SAN FRANCISCO PLANNING DEPARTMENT

Appeal of Community Plan Evaluation 429 Beale Street and 430 Main Street Project

RE: Board File No. 180697, Planning Department Case No. 2014-002033ENV – Appeal of the Community Plan Evaluation¹ for the 429 Beale Street and 430 Main Street Project. Block/Lot: 3767/305 and 306

ATTACHMENTS: A – June, 25 2018 appeal letter from Dane M. Ince
B – Planning Commission Motion No. 20195
C – Ramboll Environ’s Response to Trinity Consultants’ Peer Review of Air Quality Technical Report, March 26, 2018

Figure 1. (left) PM_{2.5} Thresholds and Maximum Project Impact. (right) Cancer Risk Thresholds and Maximum Project Impact.

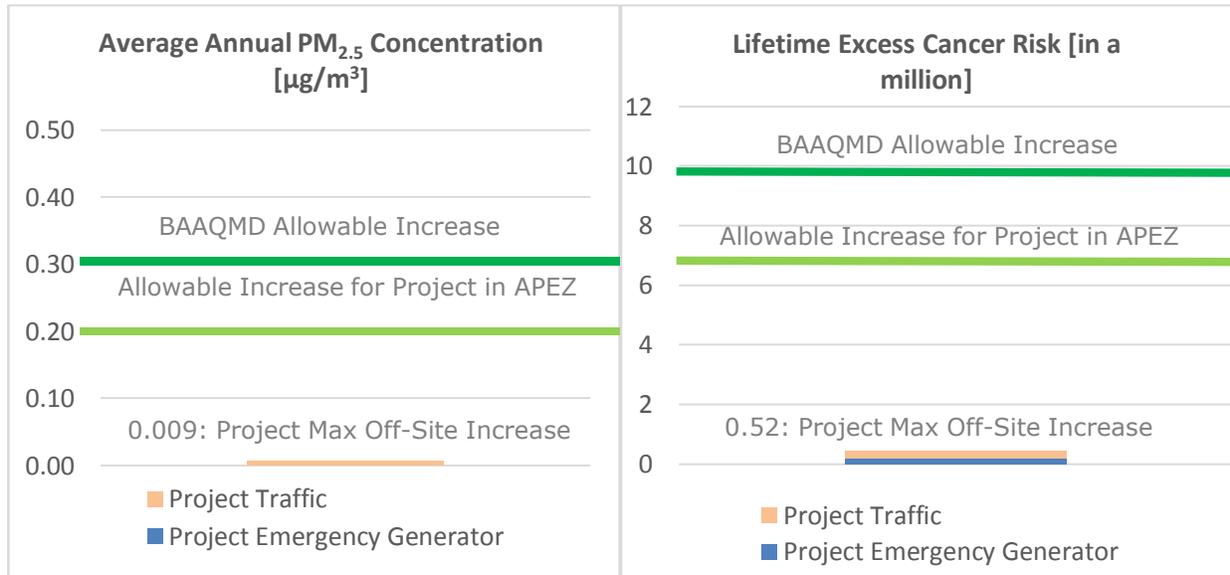
Analyses were conducted to determine whether the additional impact of the proposed Project emissions to off-site and on-site receptors would exceed these incremental thresholds. As shown in Tables 8 through 11 of the AQTR, the maximum cumulative cancer risk and PM_{2.5} concentrations from traffic plus emergency generator operations were 0.52 in a million and 0.0093 ug/m³, respectively. These maximum impacts are far below the thresholds and are therefore not considered to significantly impact health. Comparisons of the maximum Project impacts to the PM_{2.5} and cancer risk thresholds are shown in Figure 1.

Figure 2. CFD Modeling Results

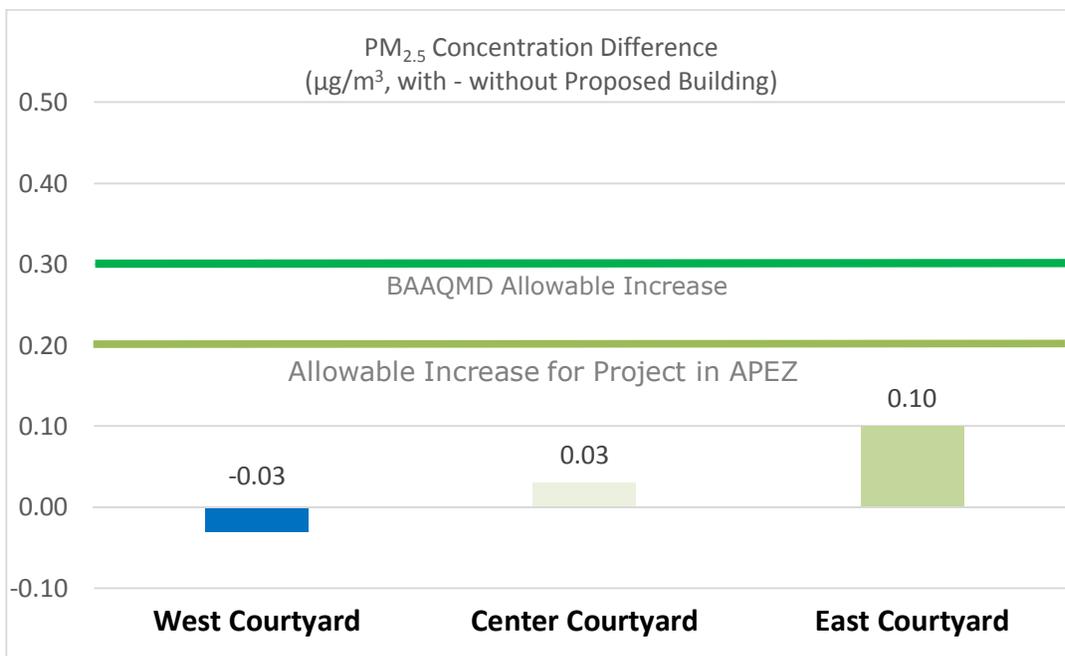
CFD modeling was performed to further visualize the potential impacts of the proposed building on existing traffic emissions dispersion in response to the 2009 CEQA appeal of a previous project on the project site. As shown in Table 13 of the AQTR, the maximum increase in PM_{2.5} concentration in any of the neighboring courtyards due to the building placement was 0.1 ug/m³. This increase would also be well below the threshold of 0.2 ug/m³, as shown in Figure 2.
